CITY OF WOODBURN
COMMUNITY DEVELOPMENT

Date: March 10, 2022
To: Dago Garcia, P.E., City Engineer
Cc: Chris Kerr, AICP, Community Development Director
Jamie Van Agtmael, PLS, President
From: Colin Cortes, AICP, CNU-A, Senior Planner *cc*
Subject: **Planning Division review comments on original submittal Feb. 8 of civil engineering plans for Allison Way Apts. Ph. 2**

Planning Division staff identifies revisions needed before sign-off on Public Works Department Engineering Division approval and issuance of civil engineering plans for Allison Way Apartments Phase 2 (DR 2019-05) along the east/southeast side of Allison Way south of Hooper Street.

COMPOSITE UTILITY LAYOUT
 SCALE: 1" = 50'
 PROJECT NO: 60-10
 SHEET: 04 OF 34
 UT-1

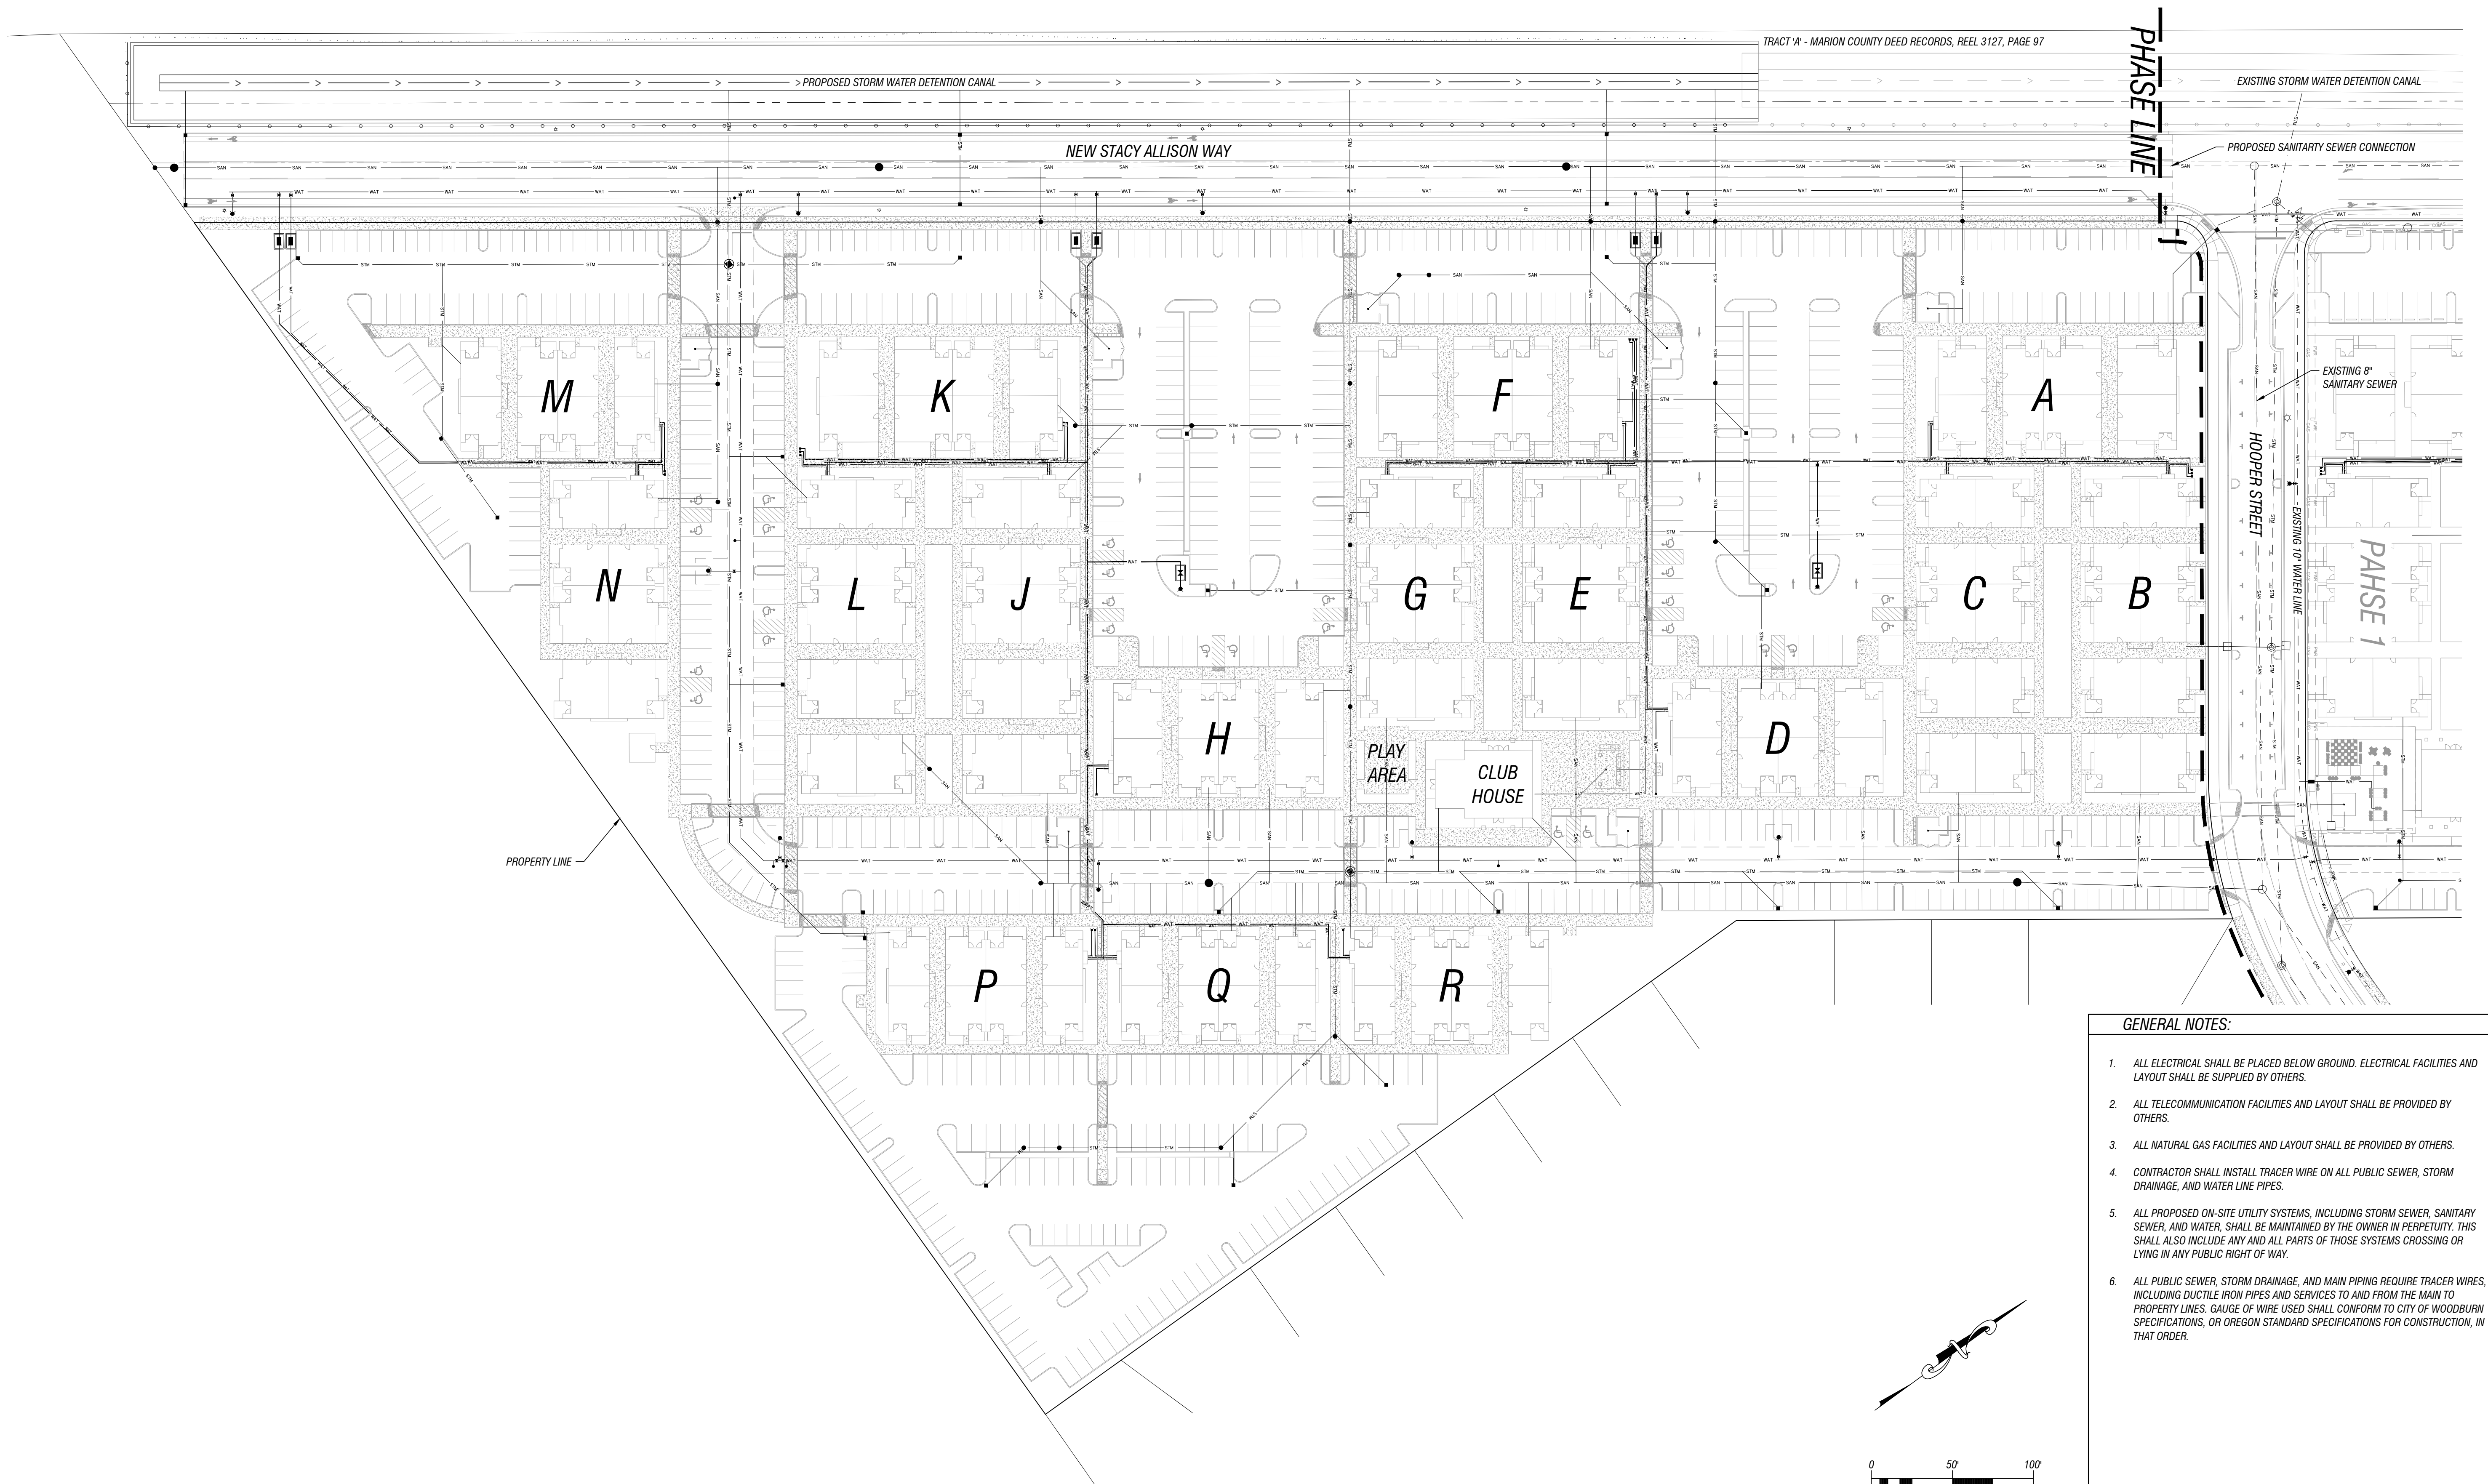
- J. Condition V6-3-2c(2). The access way 8-ft width extends south to near the BBQ area. Extend to the clubhouse southwest doors / play area by widening the three narrow walkway segments. Revise Sheets GR-7 / 17 & GR-8 / 18.
- K. Condition V9-2: Indicate number of apartments, the conditioned parking ratio of 1.9 stalls per dwelling, minimum number of stalls required, and proposed number of stalls. Revise at least Sheets UT-1 / 4 & SP-1 / 25.
